CITY OF QUINCY, MASSACHUSETTS  
ELM AVENUE AND SEA STREET WATER MAIN REPLACEMENTS

ADDENDUM NO. 1

**SKE-1**

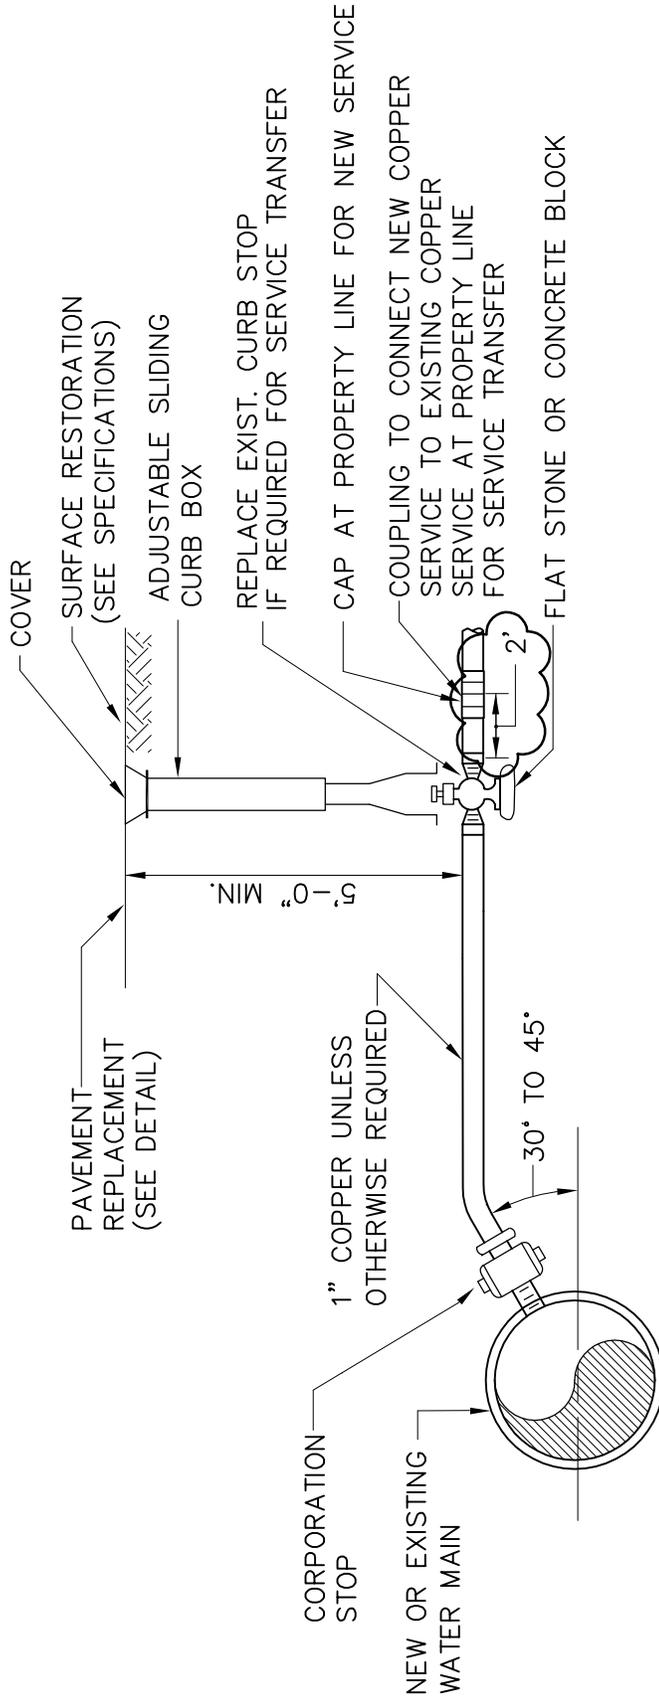
1. Revise Sheet D-2 based on attached SKE-1.

1. PROVIDE SADDLE FOR ALL AC AND PVC MAINS AND ALL 2" OR LARGER STOPS.
2. REPLACE ALL NON-COPPER WATER SERVICES FROM THE WATER MAIN TO THE HOUSE WATER METER WITH THE SAME SIZE AS THE EXISTING SERVICE, EXCEPT NO SERVICE SHALL BE LESS THAN 1" IN DIAMETER.
